Model: Kir-C ADF (I	DF72)	ate: 24-May-0)1	No.: MB387001	
Modified Article: F	Parts Catalog Correction	Prepared	by: ĸ.	Miura	
From: Technical Ser	rvices Dept., GTS Division				
Reason for	□ Parts catalog correction	☐ Vendor	change	☐ To n	neet standards
Modification:	☐ To improve reliability		()	
	☐ Part standardization	☐ Other

Model: Kir-C ADF (DF72)

Modification Bulletin

Page 9
- Part Number Change -

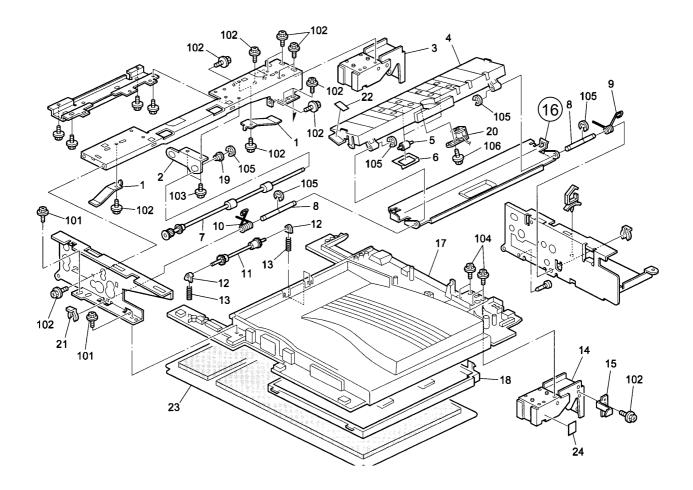
Old part	New part	Description	Q'ty	Index	Note
number	number				
B3873413	B3873410	Cover – Exit Guide Plate	1	16

Page 11 - Part Number Change -

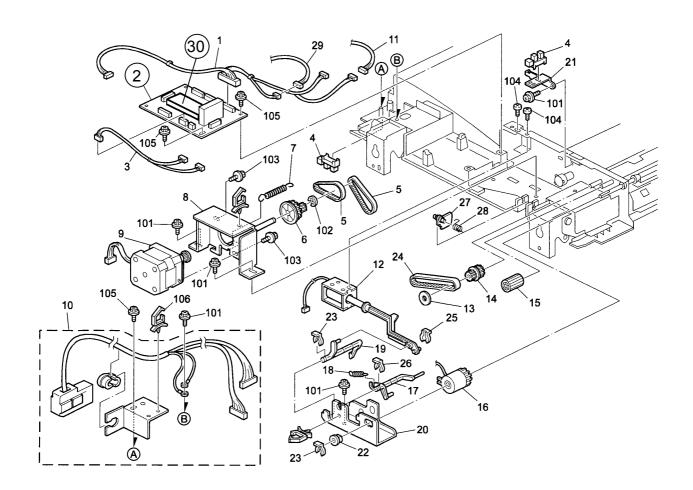
Old part number	New part number	Description	Q'ty	Index	Note
B3875500	B3875510	Main Control Board	1	2

Part number	Description	Q'ty	Index	Note
B3875660	ADF ROM	1	30

Page 2, 3

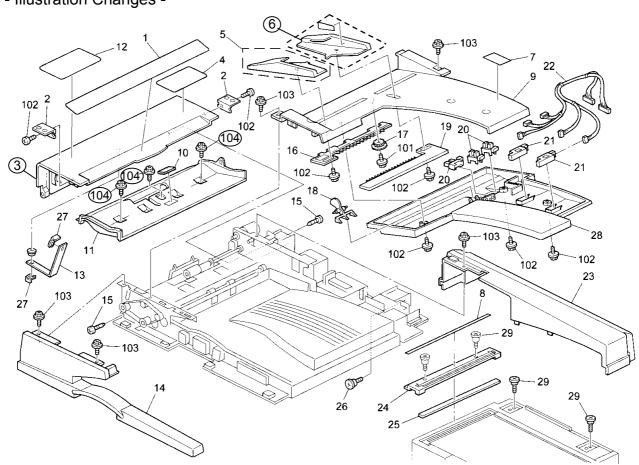
- Add the following part -

Part number	Description	Q'ty	Index	Note
04513006B	Tapping Screw – M3x6		104

Page 12
- Illustration Change -

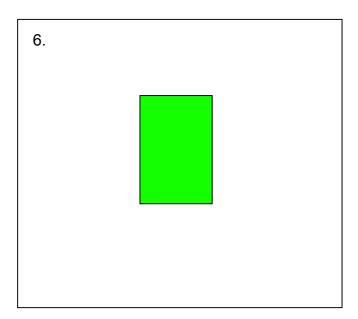
- Illustration Changes -

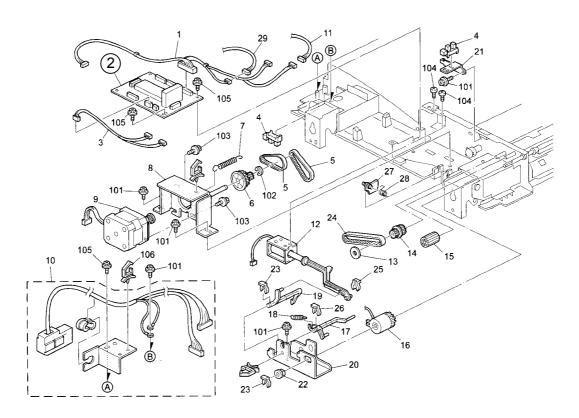
When feeding custom size originals with the ADF (B387), the second original will jam when the actual length is from 118 mm to 172mm. To ensure this does not occur, the following part has been changed. Please refer to RTB #RB040014 for further details.

ľ	Old part number	New part number	Description	Q'ty	Int	Page	Index	Note
I	B3875510	B3875520	Main Control Board	X/O	1	11	2

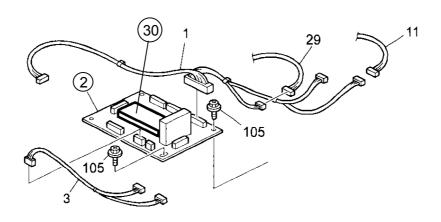
To prevent original jams, the following part has been changed: For details, refer to RTB #RB040008.

Old part	New part	Description	Q'ty	Int	Page	Index	Note
number	number						
B3875520	B3875530	Main Control Board	1	X/O	11	2	
B3875660	B3875680	ADF ROM	1	X/O	11	30

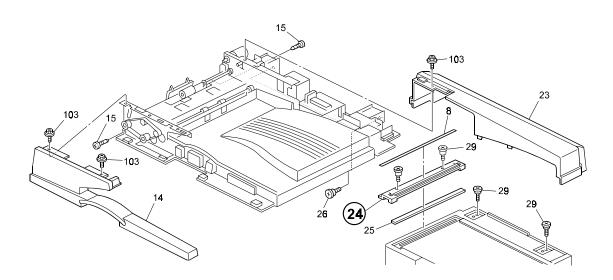
The shape of the Original Scale has been changed to ensure smoother feed of originals.

Old part	New part	Description	Q'ty	Int	Page	Index	Note
number	number						
B3867101	B3867102	Original Scale	1	0/0	3	24

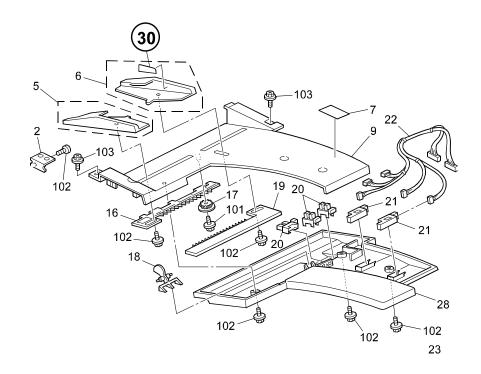
Please add the following part to your Parts Catalog:

New part number	Description	Q'ty	Page	Index	Note
B3876042	Side Fence Decal	1	3	30

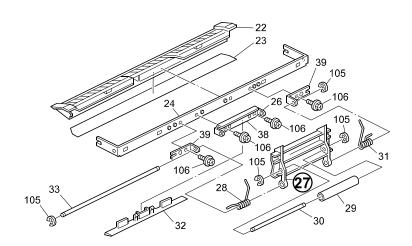
The following has been changed to ensure that curled originals do not contact the Transport Driven Roller Cover and jam.

Old part	New part	Description	Q'ty	Int	Page	Index	Note
number	number						
B3873316	B3873322	Cover - Transport Driven Roller	1	X/O	5	27

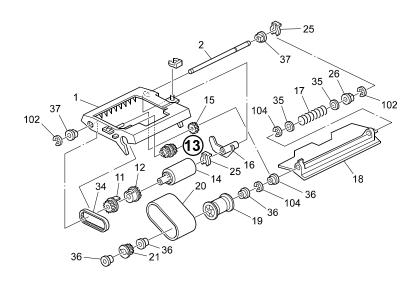
The following has been changed due to parts standardization with the DF71.

Old part number	New part number	Description	Q'ty	Int	Page	Index	Note
A8592168	G4123831	Pulley - 22Z	1	0/0	5	13
